Certificate of Appropriateness
946 Jenifer St

January 11, 2021

Southeast Elevation

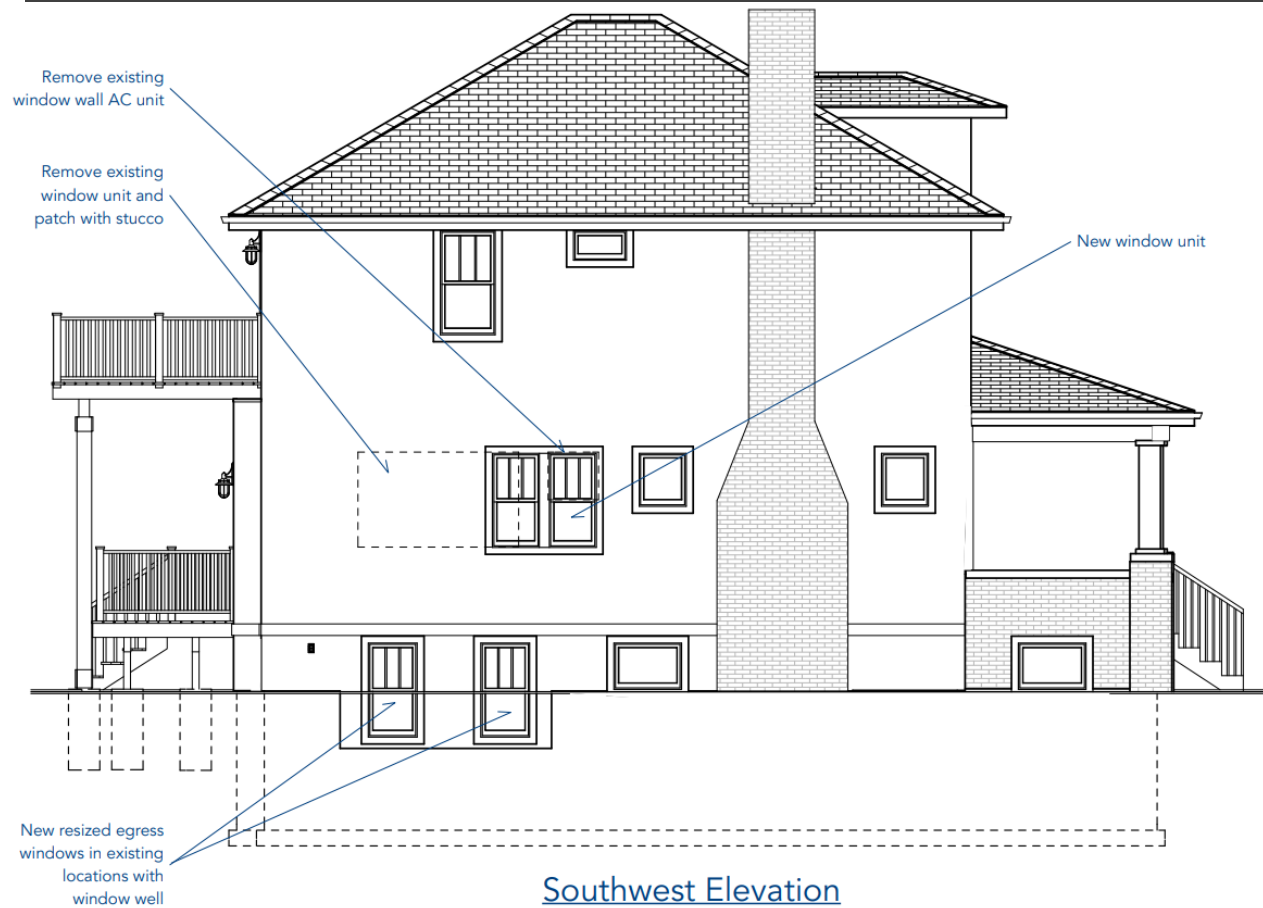
NOTE: All new and existing windows (inserts) to be replaced with Marvin Ultimate Double Hung G2 windows with Simulated Divided Lite with Spacer Bar (SDLS). See attachment for product details.

Northwest Elevation

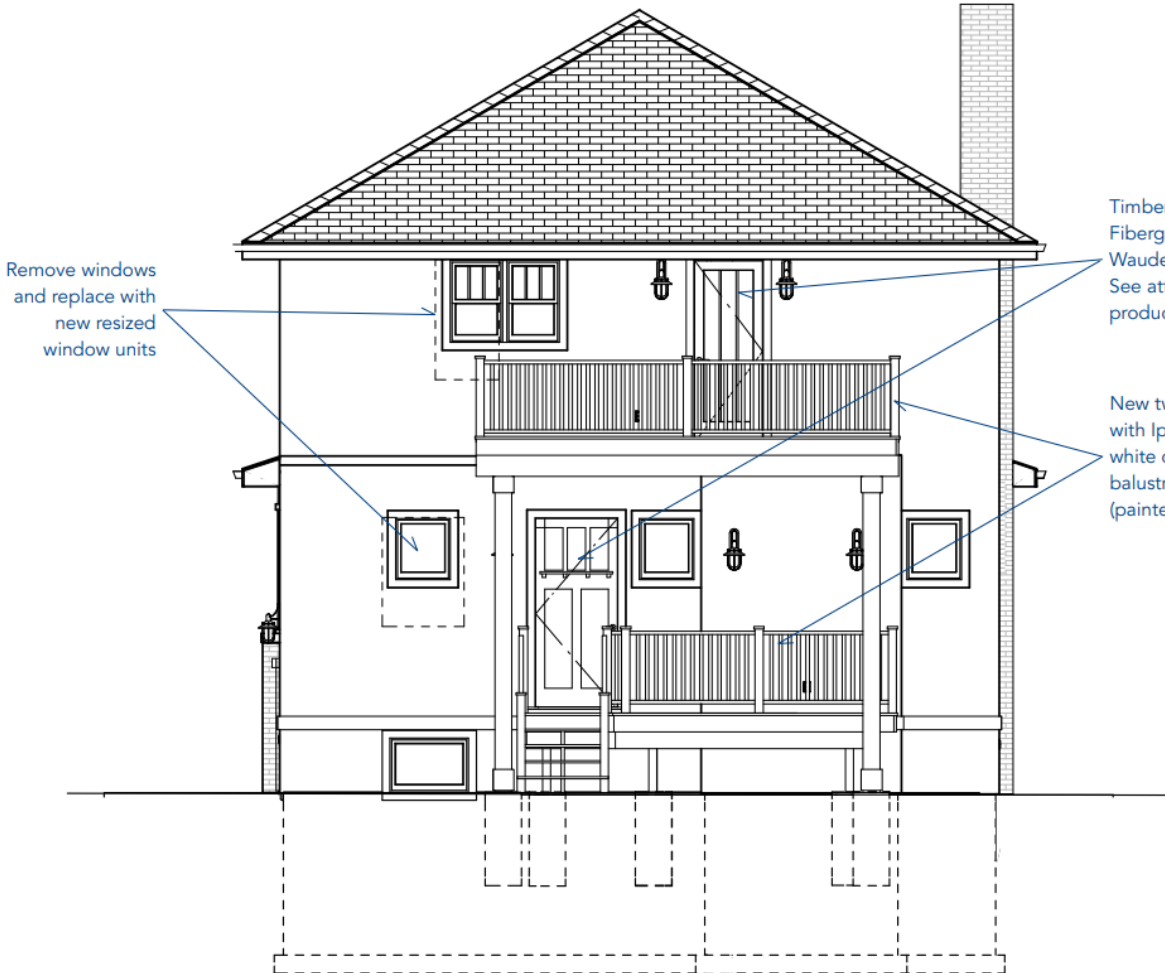
Timberline Smooth Fiberglass doors by Waudena (painted). See attachment for product details.

New two-level deck with Ipe decking and white cedar balustrade and posts (painted).

Northeast Elevation

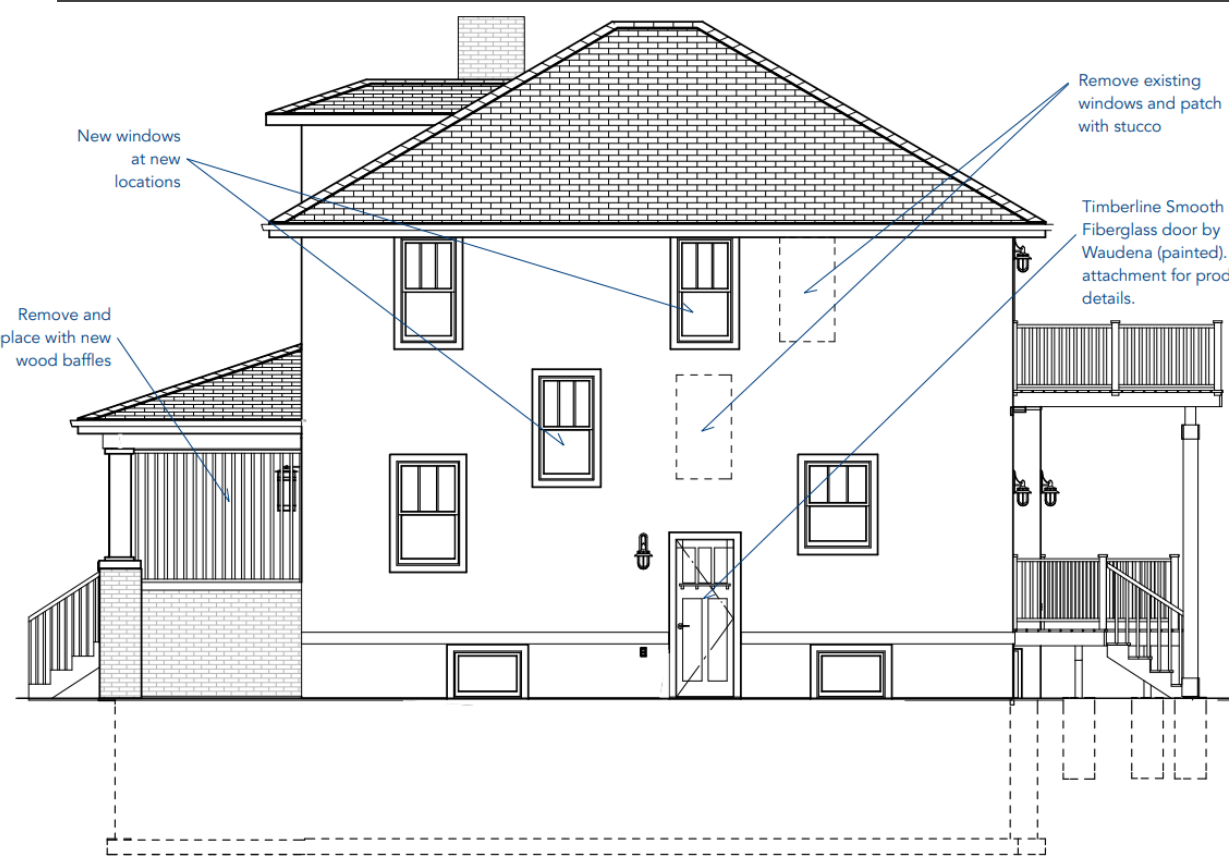
Remove windows and replace with new resized window units

Remove existing windows and patch with stucco

Timberline Smooth Fiberglass door by Waudena (painted). See attachment for product details.

New windows at new locations

Remove and replace with new wood baffles
